Please see the attached map provided to me by National Grid of the area of my land that will be affected. I would like the construction route (red) closer pushed to the field boundary.

Title
NG-NT-2025-06-GF-CON-R3_5111-2

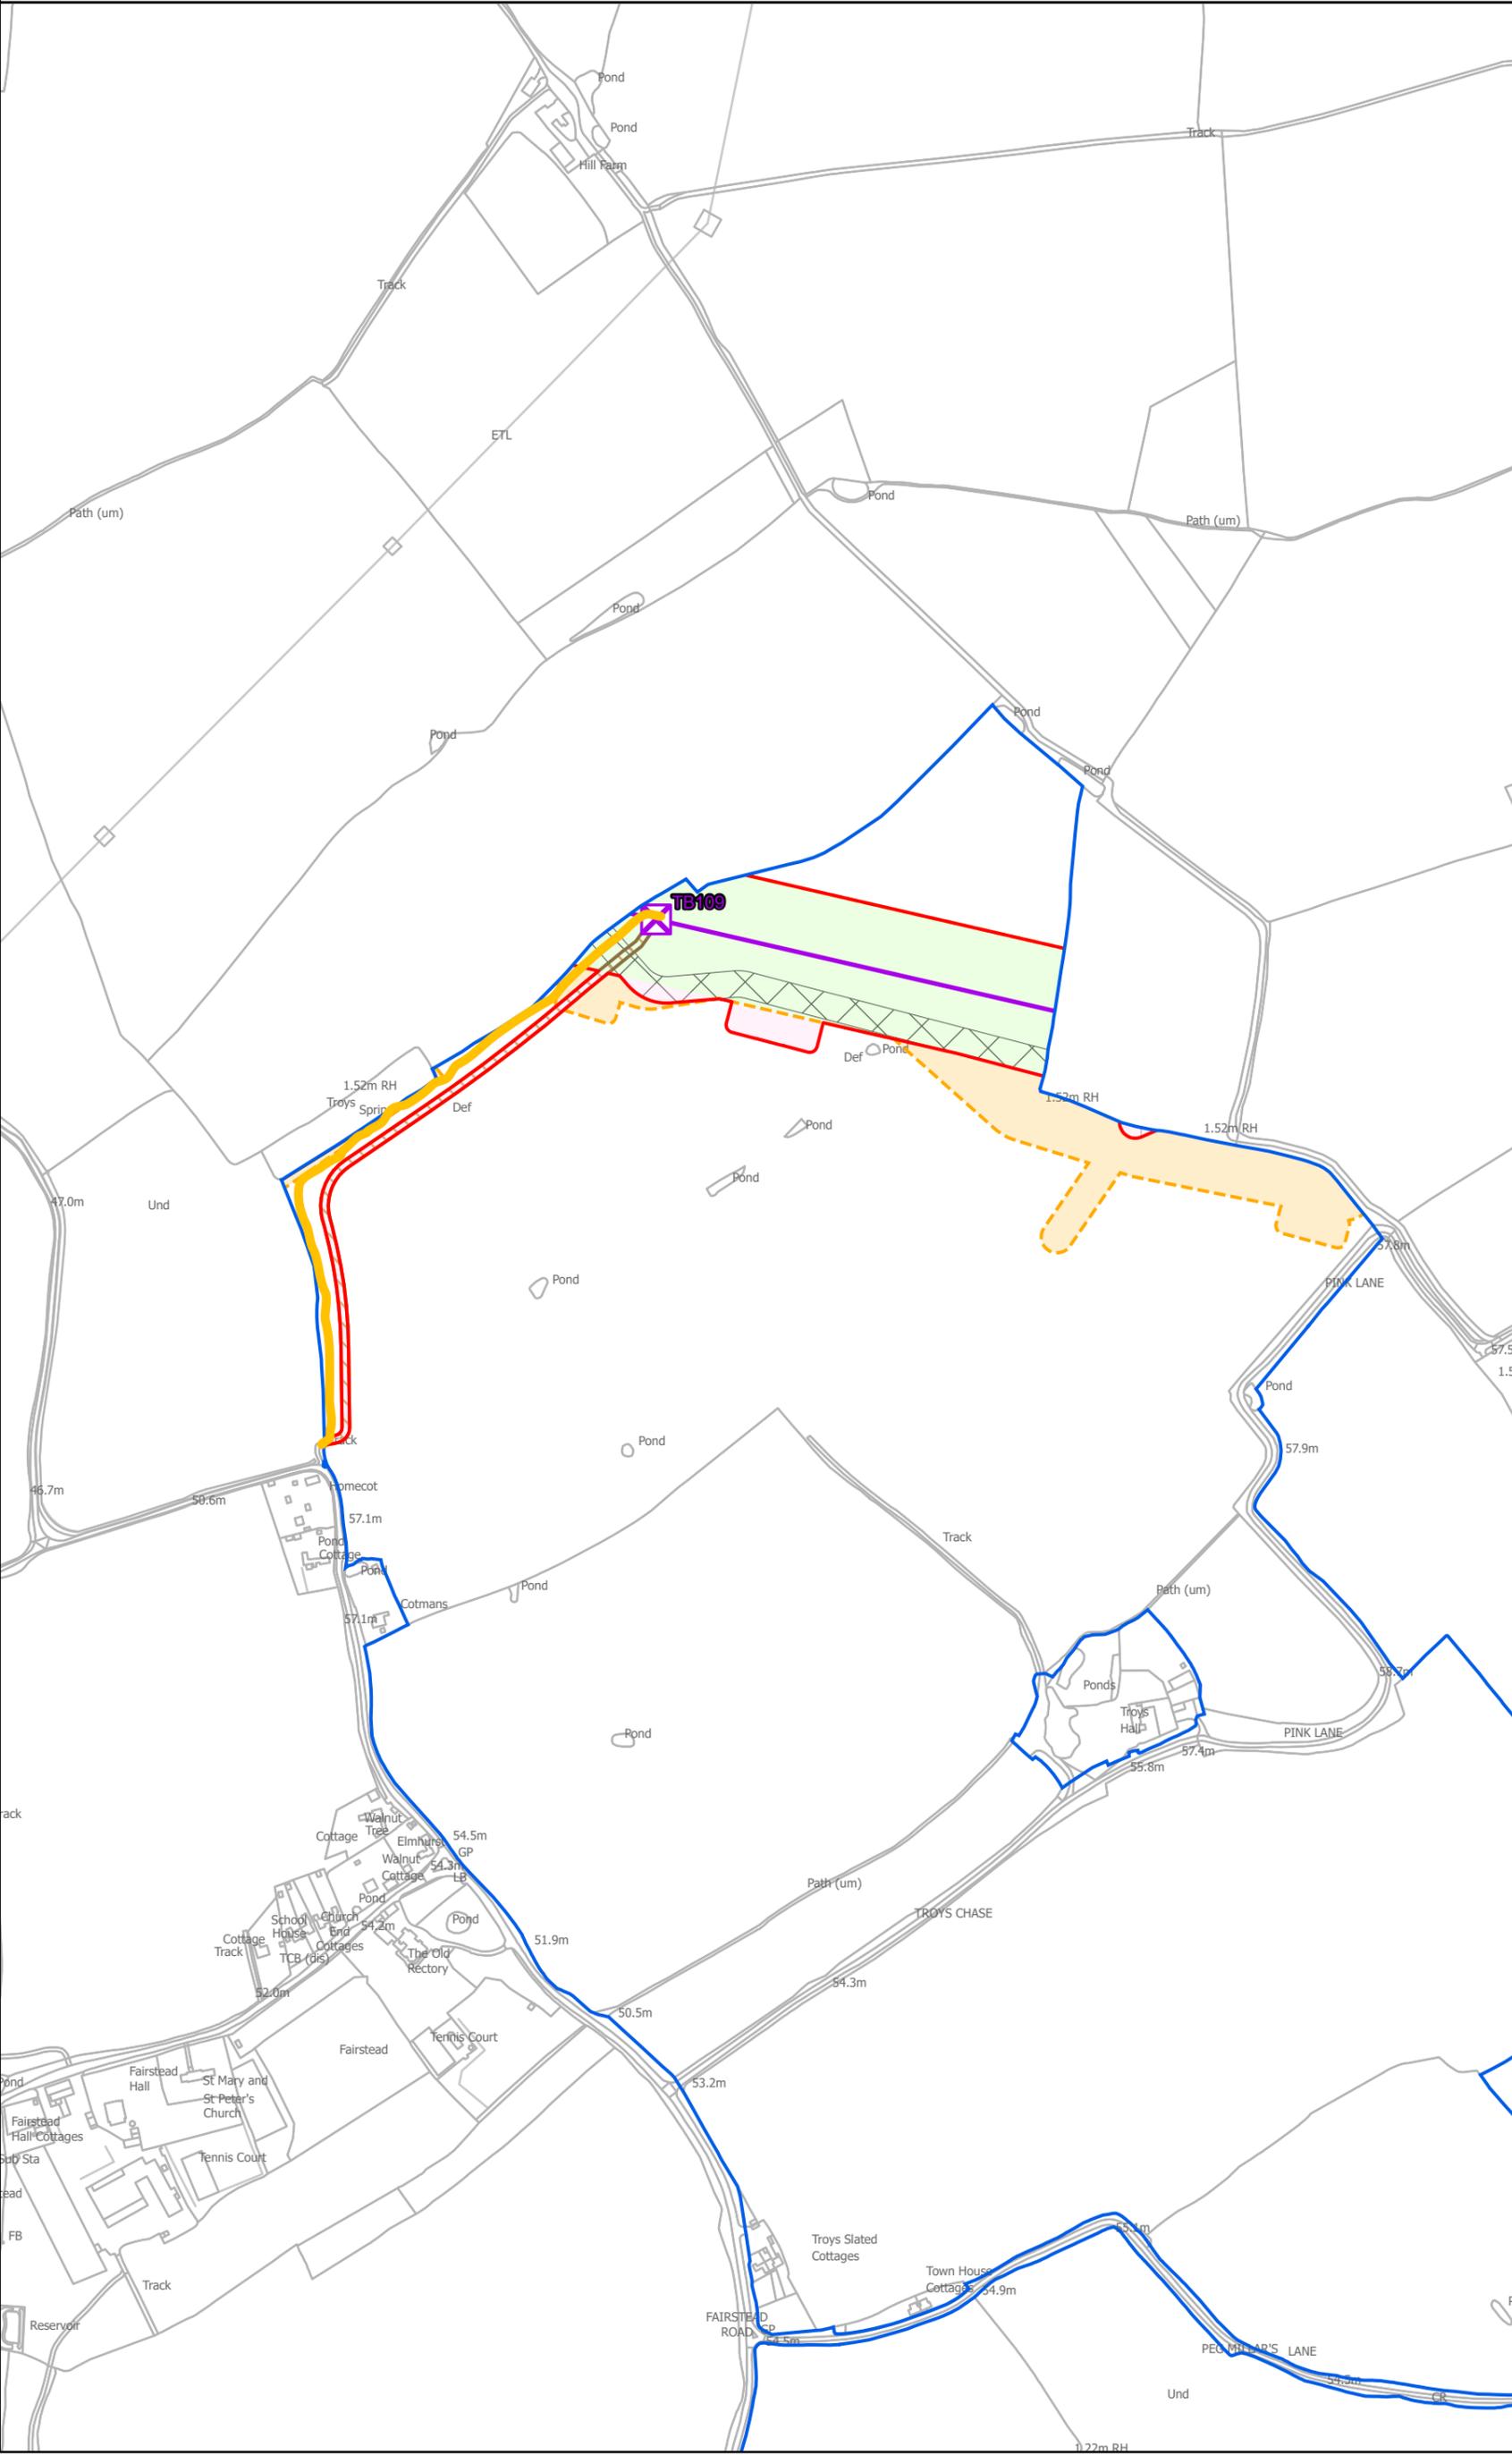
During construction, the land in the northern corner will not be accessible. I would like to be compensated for lost income from cropping this corner of land as well as the land you are occupying for construction.

No compulsory purchase is required on any of my wayleaves should be sufficient as in other locations on my land.
